STAFF REPORT: NOVEMBER 10, 2021 MEETING

APPLICATION NUMBER: 21-7610

ADDRESS: 2277 LONGFELLOW

SCOPE: ERECT NEW ADDITION TO GARAGE, INSTALL GARAGE DOORS AND EXTERIOR CLADDING ON GARAGE; ERECT WOOD GAZEBO AT REAR YARD

Applicant photo, November 2021

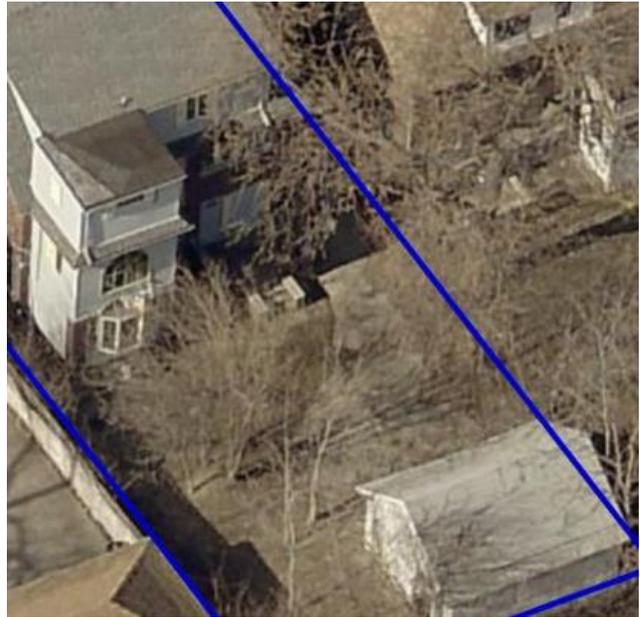
- The third bay is setback from the original structure and has a lower roof ridge, giving it a clearly defined appearance of an addition.
- Due to the position of the garage on the lot, the expanded size is obscured from the public right-of-way.

- The proposal retains the original two car openings.
- Based on the Pictometry images, the previous design of the garage was sympathetic and deferential to the main house. It is staff's opinion the brick and cementitious siding, as proposed, is an appropriate selection for the garage.

**2277 LONGFELLOW ST
HARDSCAPE PLAN**

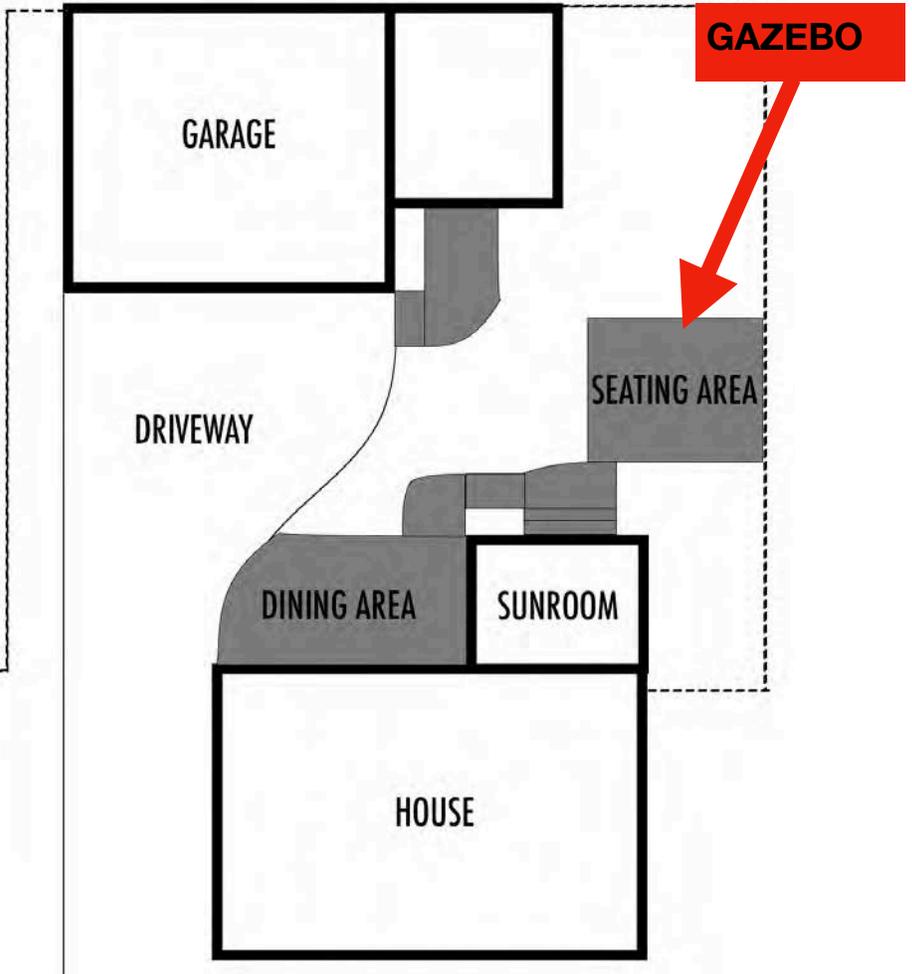
- Staff isn't sure that the site plan and proposed gazebo placement are correct and if the structure will be placed directly against the fence. Staff asked the applicant to submit dimensions of the structure from the inside edge of the front sidewalk (nearest the house) to the north wall of the gazebo, to determine how well might it be seen from the right-of-way. Also requested is the width of the side yard, from the west edge of the house to the west-side lot line, to determine how far the gazebo may extend past the west edge of the house and if it really will sit against the fence.
